# 1957 - 1958 Corvette: Service News: Corvette 4-Speed Transmission - Harsh Shift Into Third Speed

**Source:** Chevrolet Service News

**Date:** December, 1957

**Subject:** Corvette 4-Speed Transmission - Harsh Shift Into Third Speed

*Fig. 3--Checking Third Speed Gear*

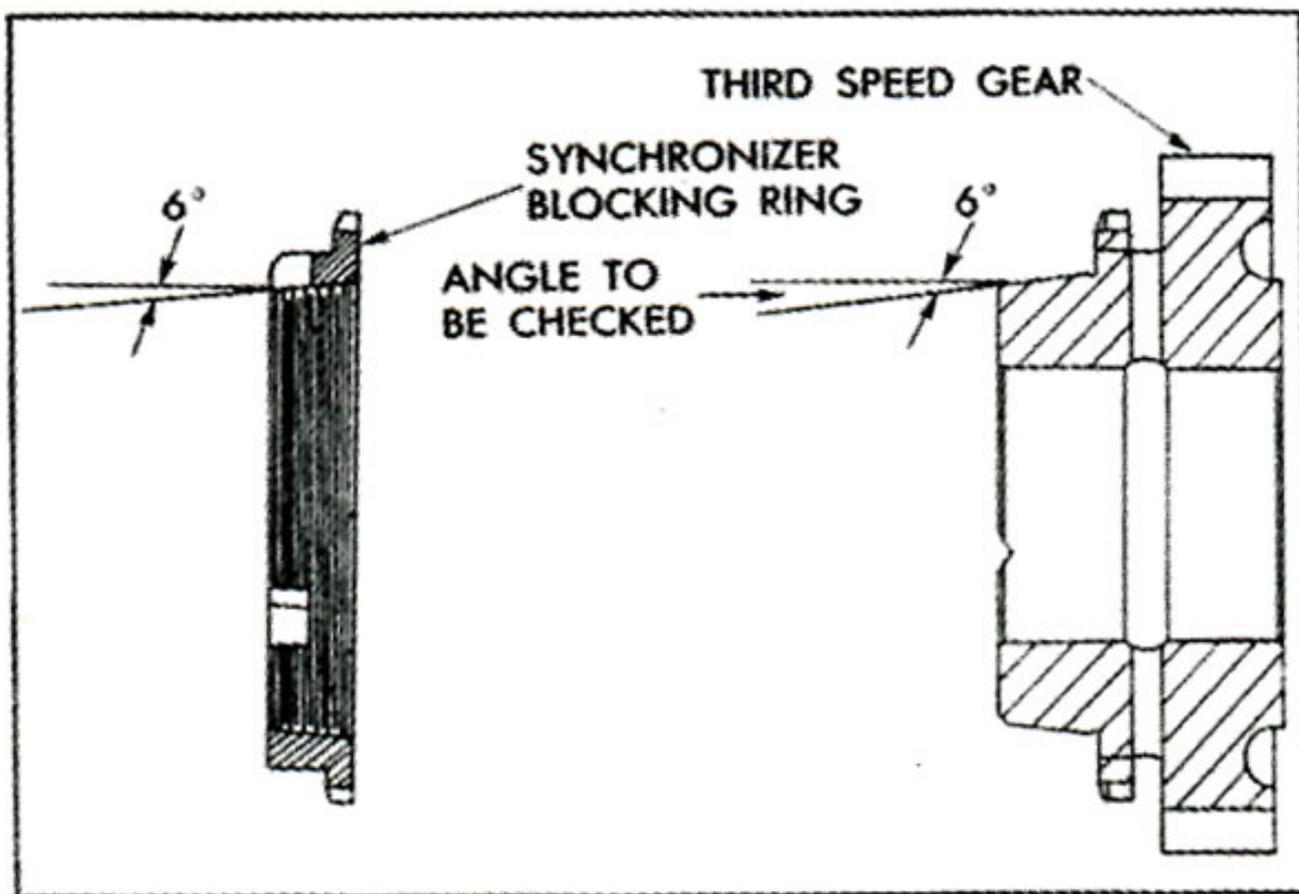
Some 1957 and 1958 Corvette four-speed transmissions have been built incorporating a third speed gear with  $7^{\circ}$  cone angle rather than the specified  $6^{\circ}$ , as illustrated in Figure 3. This may cause a harsh shift into third speed due to the resultant improper engagement of the synchronizer blocking ring and third speed gear cone.

The suggested correction, if the harsh shift is encountered, is to replace the third speed gear assembly No. 3743452 and the synchronizer blocking ring No. 3709348.

1. Coat I.D. of blocking ring lightly with a dye such as Prussian Blue.
2. Carefully install the blocking ring on the third gear cone to obtain an engagement impression.
3. If the Prussian Blue impression on the cone is all at the rear (or predominantly at the rear) the cone angle can be assumed to be  $7^{\circ}$  and should not be used. If the Prussian Blue is more or less evenly distributed on the cone surface, the angle is correct.
